QUIKTRIP NO. 4245 SITE PLAN WITH CONDITIONAL USE

LOCATED AT THE NORTHEAST CORNER OF E ALAMEDA AVE AND S CRYSTAL STREET
 LOCATED IN THE SW QUARTER OF SECTION 7, TOWNSHIP 4 SOUTH, RANGE 66 WEST OF THE 6TH PRINCIPAL MERIDIAN
 CITY OF AURORA, COUNTY OF ARAPAHOE, STATE OF COLORADO

Comments in green were made by PW Engineering reviewer Sergio Um. Please contact him at sum@auroragov.org for any comments or questions.

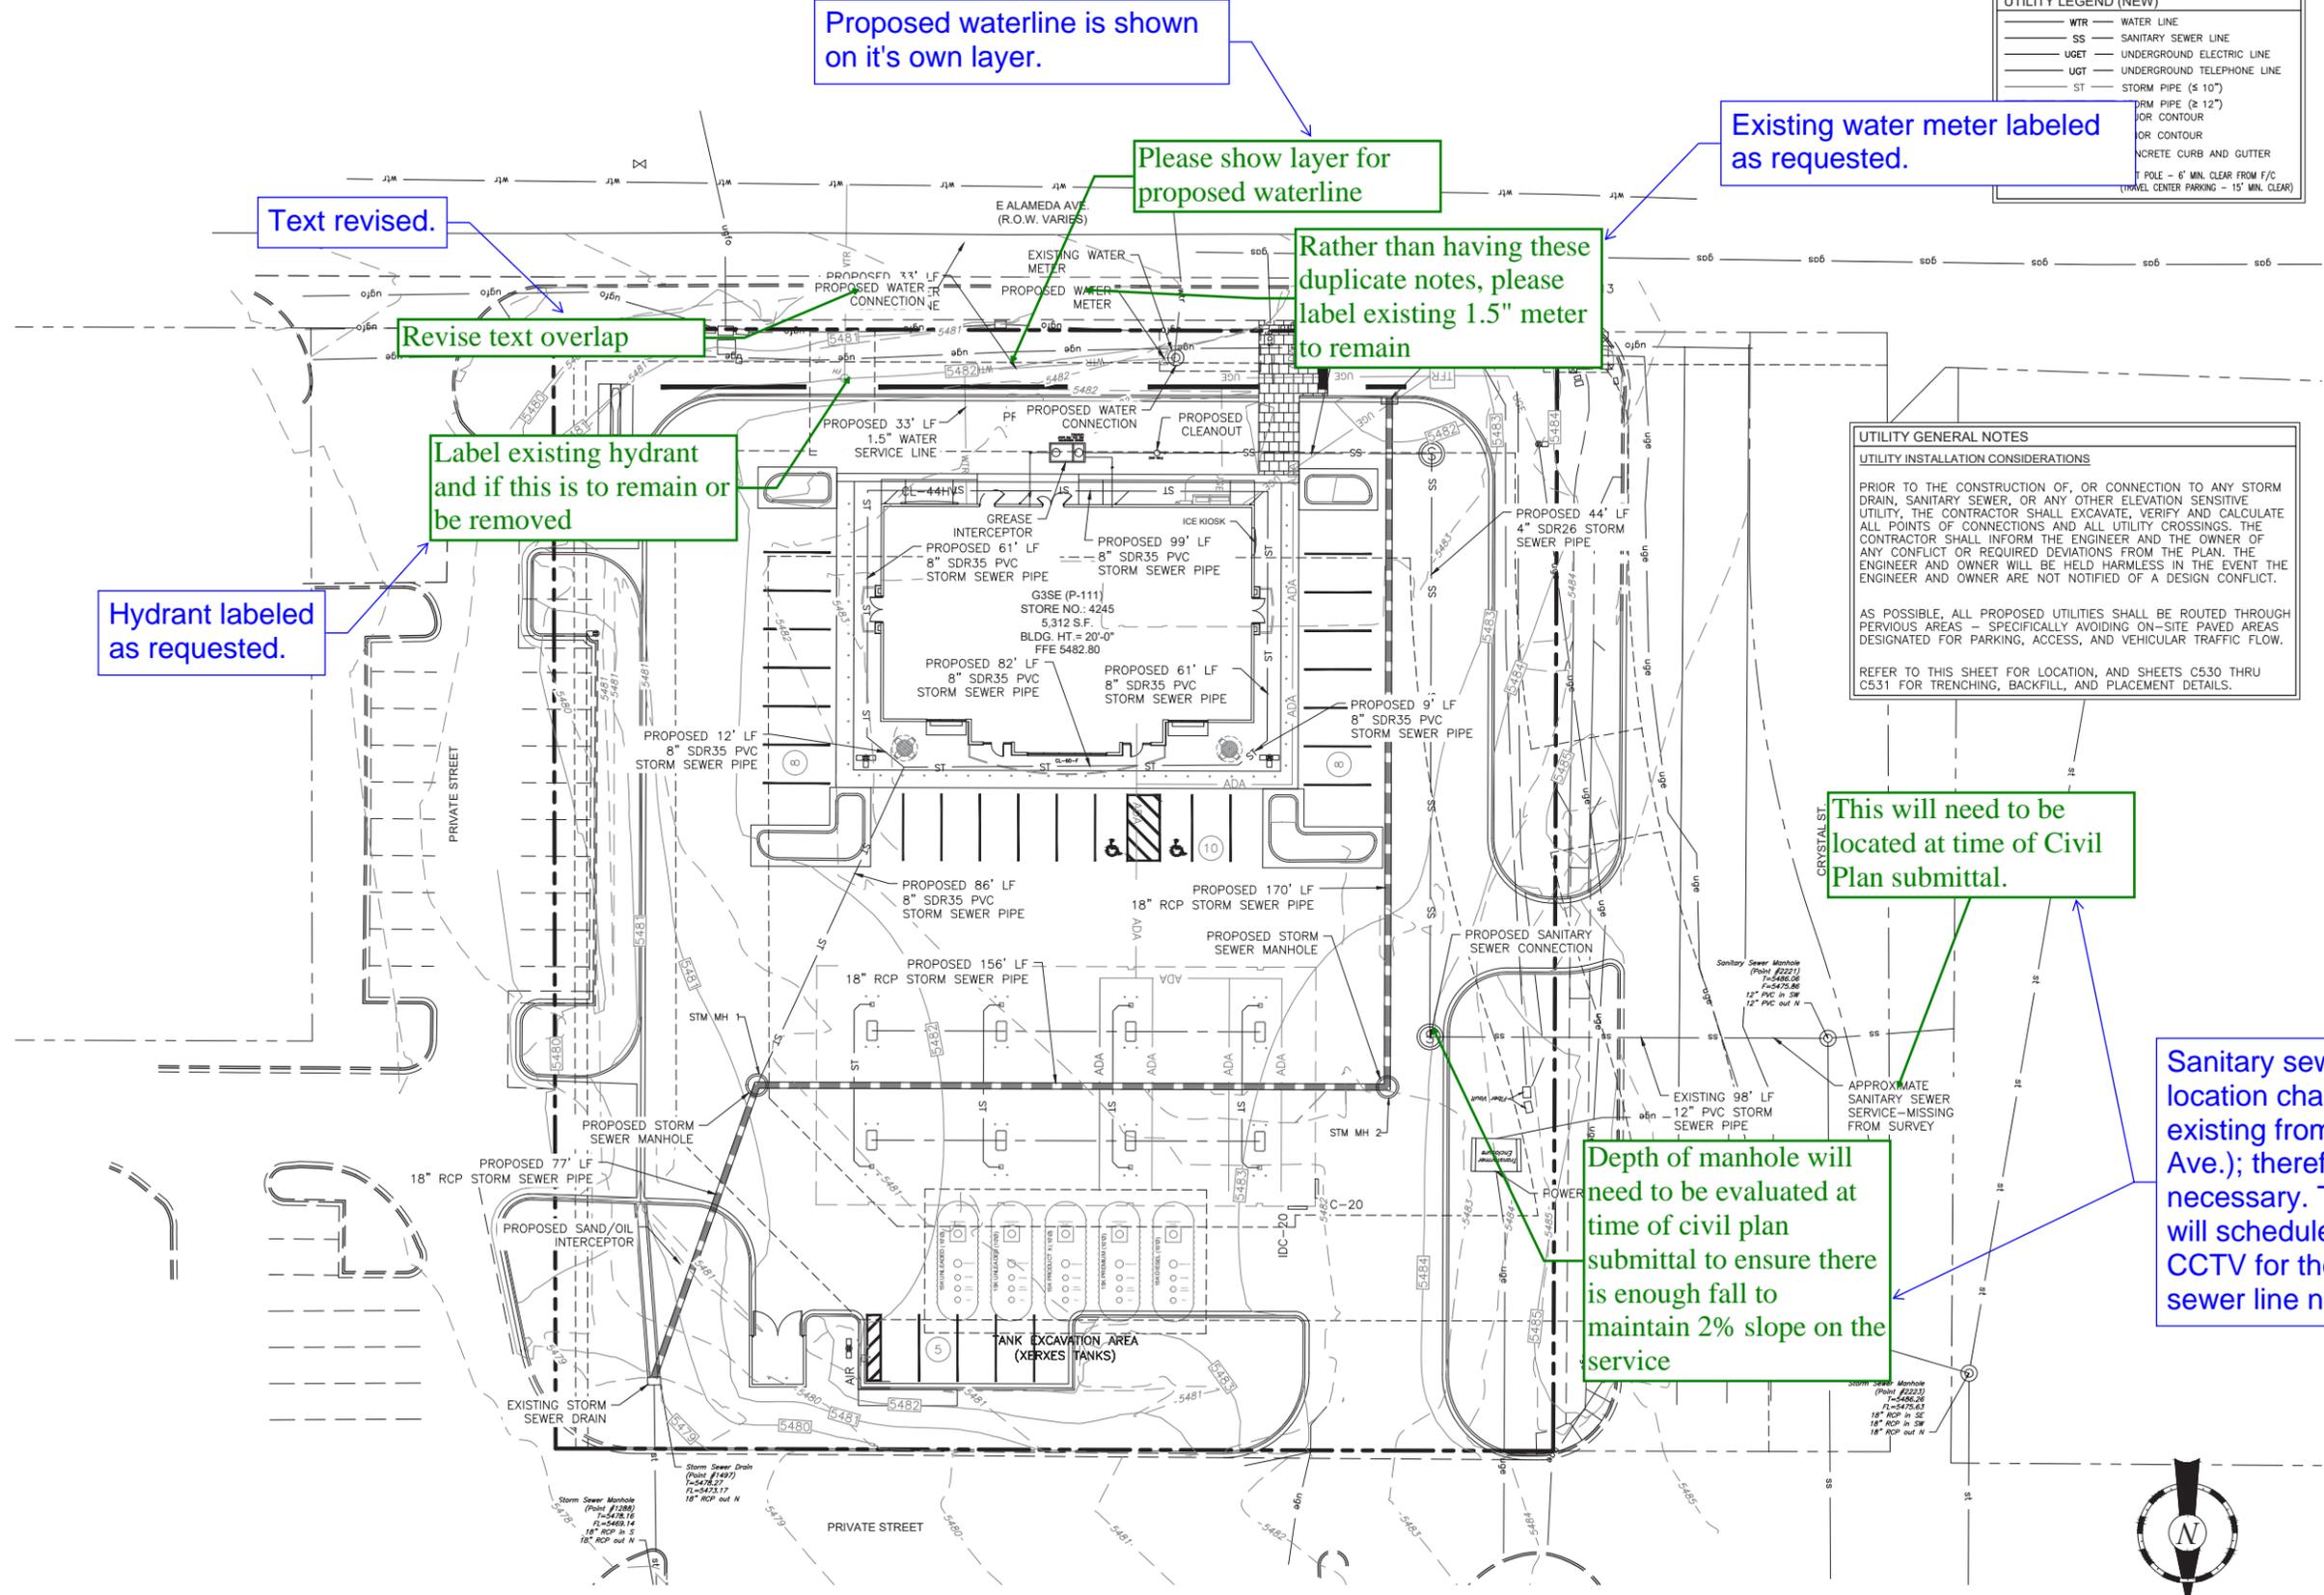
Show more slopes throughout site, not a lot of slopes shown at landscaping surfaces. Minimum grades shall be: -0.50% for concrete surfaces -1.0% for asphalt surfaces -2.0 for all grass-lined swales, landscape areas, and all non-paved areas. (2.08.1.06 of the 2023 COA Roadway Manual)

Type and dimension of easement or tract shall be clearly labeled. R.O.W. and street widths shall be dimensioned. (2.06.1.01 of the 2023 COA Roadway Manual)

Show longitudinal and cross slopes along fire lane to ensure maximum slopes are not exceeded. Maximum slopes shall be 10% longitudinal, 4% cross slope, and 4% resultant slope. (2.08.1.06.2 of the 2023 COA Roadway Manual)

Minimum slope away from a building shall be 2% (impervious) for at the first 10' away from the building. Due to the ADA path being around the building, aim for a 1.8% cross slope. (2.08.1.06.2 of the 2023 COA Roadway Manual)

Specify pole height and fixture type of all lights. Location of this lightpole does not match lighting sheet

Where is the lightpole in this area? Shown in lighting sheet

Where is contour tying in to existing?

Shown at different location in lighting sheet

Label contour

Show the resultant slope to show slopes do not exceed 2% in any direction

Missing linework, lots of unlabeled lines (easements, etc.), and overall very messy in this area. Clean up, label all easements, shade back existing features such as existing easement linework, existing contours, etc.

Show slope of trickle channel

Lightpole symbol does not match lighting sheet

Show contour tie ins

Response: Additional slopes added throughout the site. Grading shall meet all requirements of the 2.08.1.06 of the 2023 COA Roadway Manual.

Response: All easements and tracts have been clearly labeled and dimensioned. Street widths have also been dimensioned.

Response: Fire lane removed.

Response: Slopes around the building will be from 2% max to 1.5% minimum to meet ADA and COA Roadway Manual requirements.

Response: See lighting plan for pole height. This comment is pointing to an existing light pole that will be left in place.

Response: Lighting plan will match grading/site plan.

Response: This site layout has been updated and all existing contours will tie into existing.

Response: All contours labeled.

Response: Labels and text have been cleaned up. All lots, easements and contours have been labeled. Existing features have also been screened back.

Response: Lighting plan will match grading/site plan.

Response: Resultant slope shown on ADA stalls and do not exceed 2%.

Response: Slope label added to concrete flume

Response: Lighting plan will match grading/site plan.

Response: This site layout has been updated and all existing contours will tie into existing.

Response: Lighting plan will match grading/site plan.

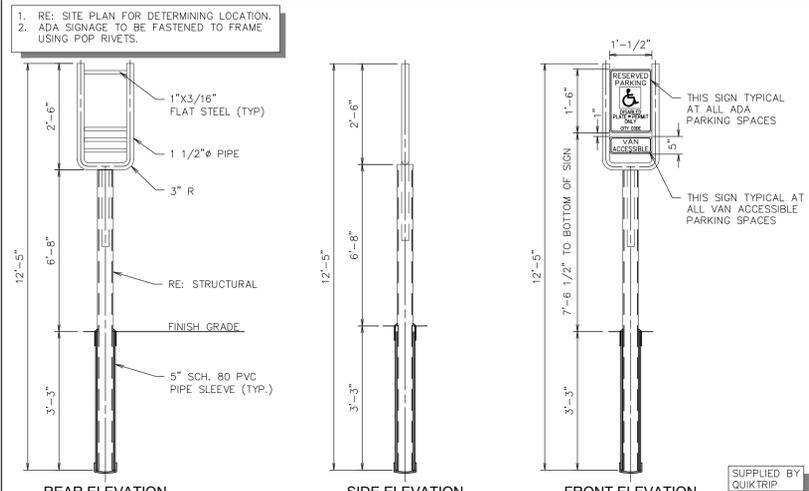
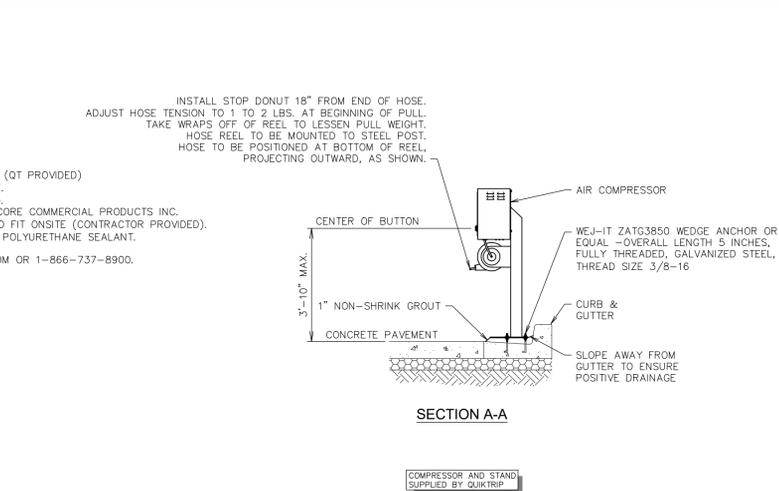
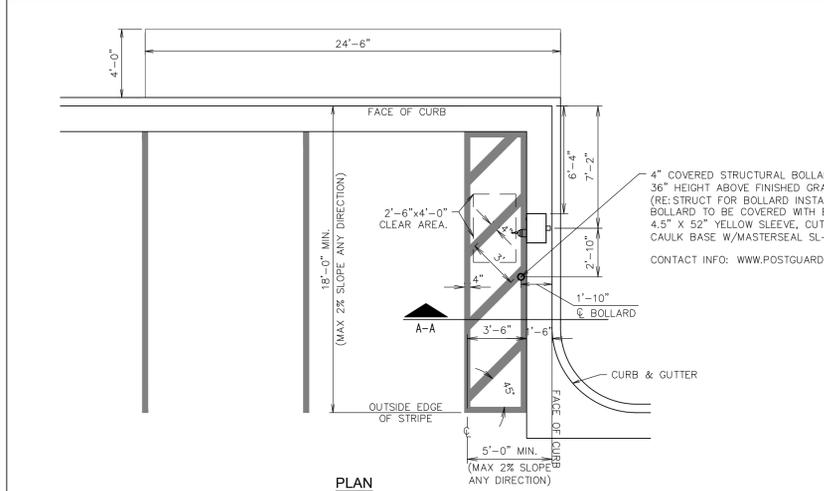
Please show layer for proposed waterline

Revise text overlap

Rather than having these duplicate notes, please label existing 1.5" meter to remain

Label existing hydrant and if this is to remain or be removed

Depth of manhole will need to be evaluated at time of civil plan submittal to ensure there is enough fall to maintain 2% slope on the service

Proposed waterline is shown on it's own layer.

Existing water meter labeled as requested.

Text revised.

Hydrant labeled as requested.

This will need to be located at time of Civil Plan submittal.

Sanitary sewer service location changed (i.e., use existing from main in Alameda Ave.); therefore, location not necessary. The design team will schedule potholing and CCTV for the existing sanitary sewer line noted above.

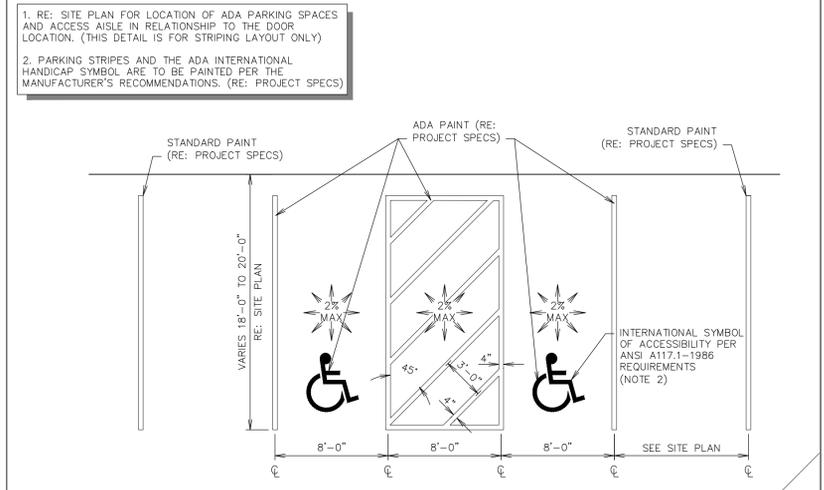
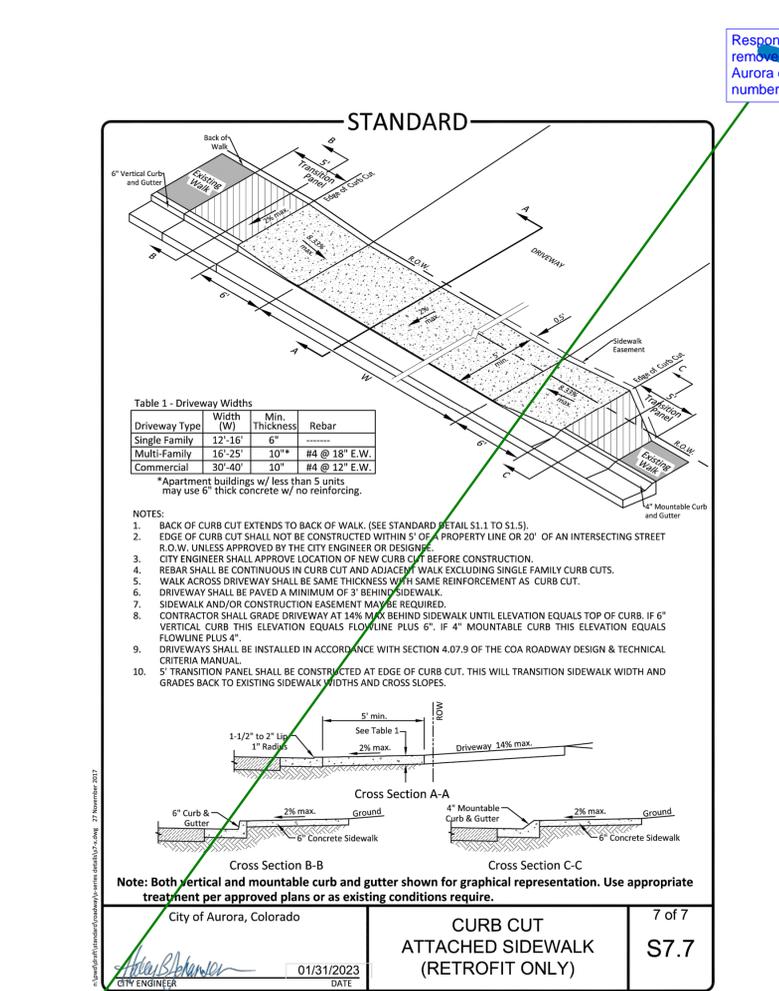
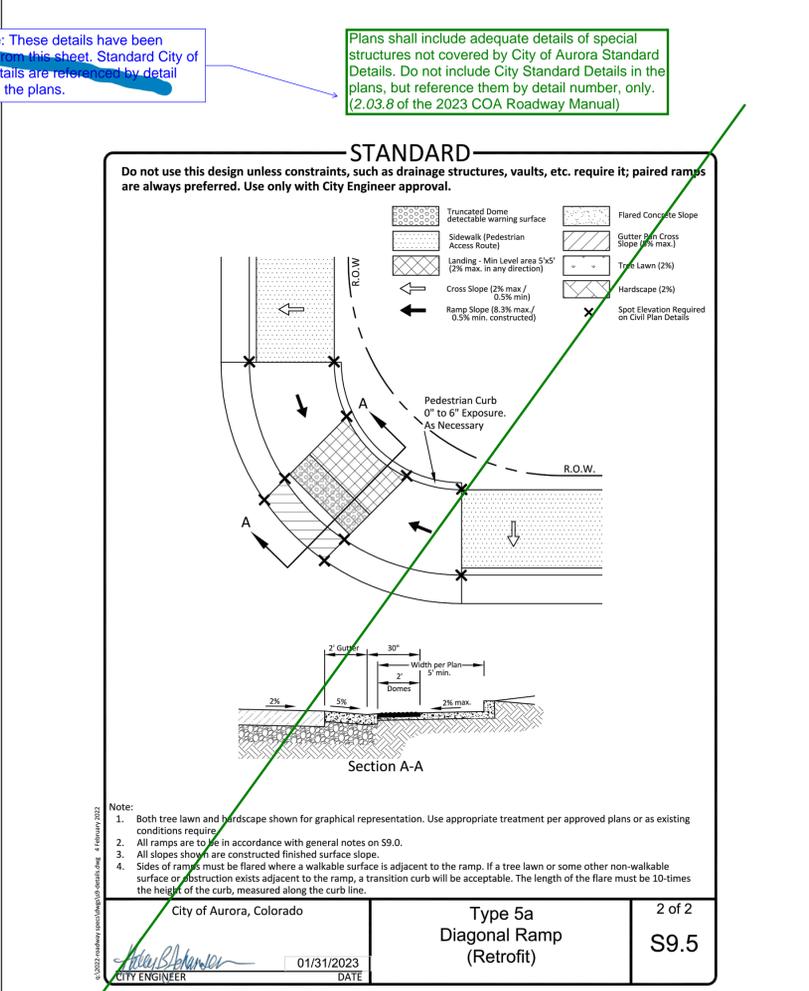
Plans shall include adequate details of special structures not covered by City of Aurora Standard Details. Do not include City Standard Details in the plans, but reference them by detail number, only. (2.03.8 of the 2023 COA Roadway Manual)

Response: These details have been removed from this sheet. Standard City of Aurora details are referenced by detail number in the plans.

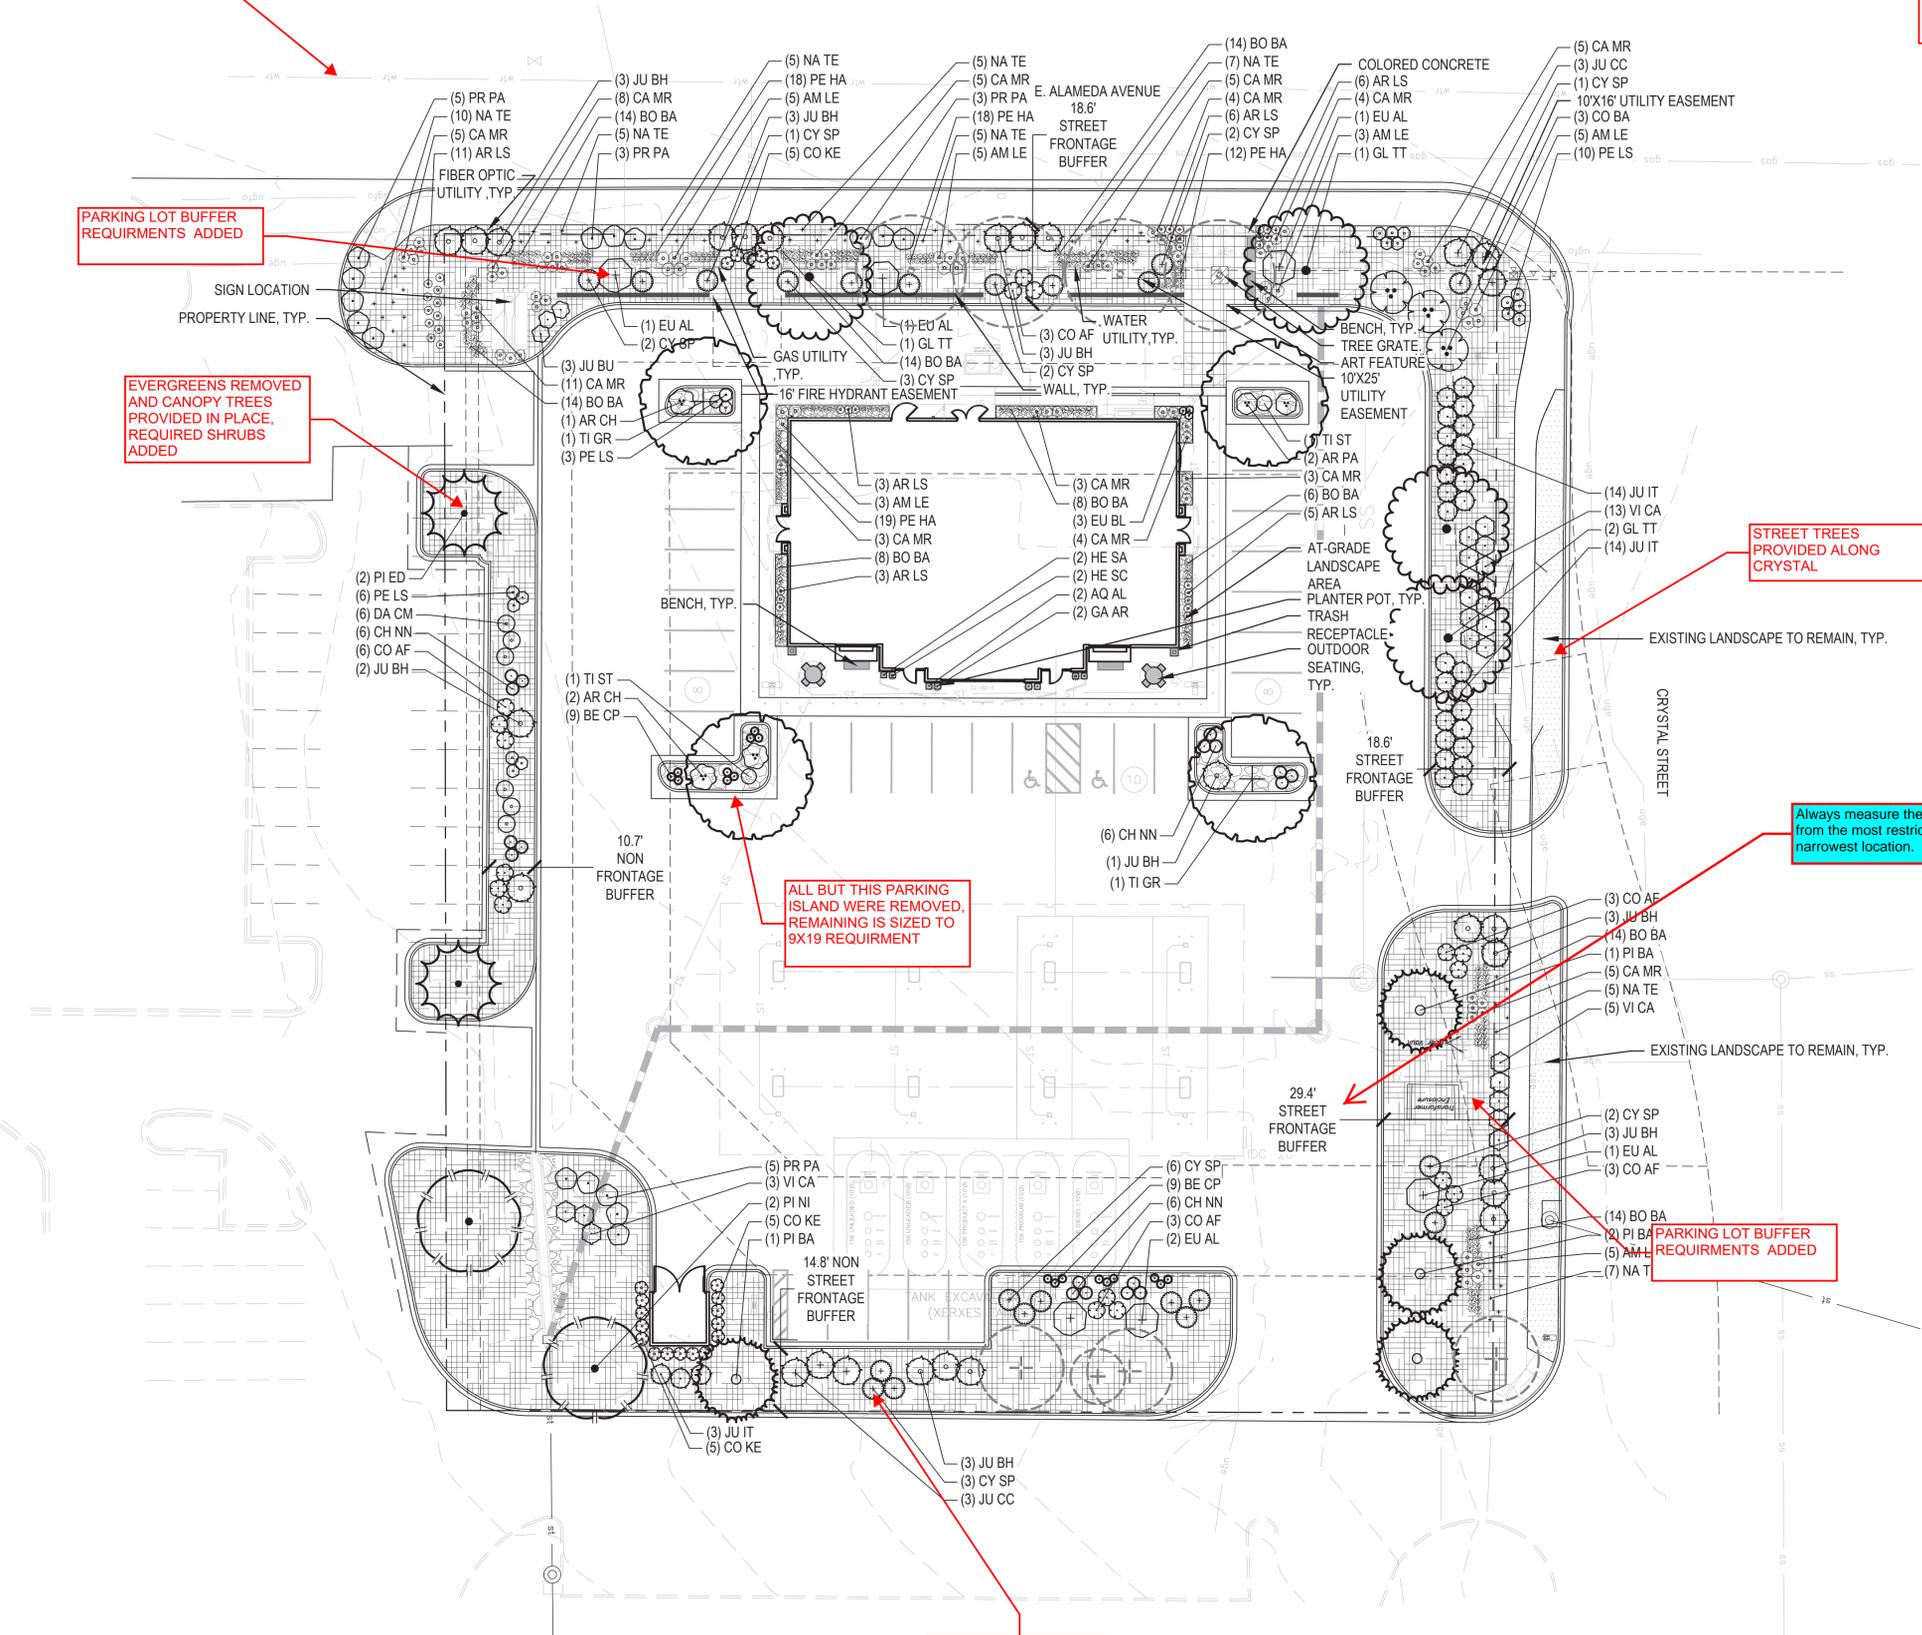
Sod twice?? Sod is not permitted. Rock mulch or pavers perhaps?

Always measure the buffer from the most restrictive or narrowest location.

LEGEND ADJUSTED, SOD REMOVED

STREET TREES PROVIDED ALONG CRYSTAL

PARKING LOT BUFFER REQUIREMENTS ADDED

PARKING LOT BUFFER REQUIREMENTS ADDED

ALL BUT THIS PARKING ISLAND WERE REMOVED. REMAINING IS SIZED TO 9X19 REQUIREMENT

EVERGREENS REMOVED AND CANOPY TREES PROVIDED IN PLACE. REQUIRED SHRUBS ADDED

PARKING LOT BUFFER REQUIREMENTS ADDED

UTILITIES DARKENED
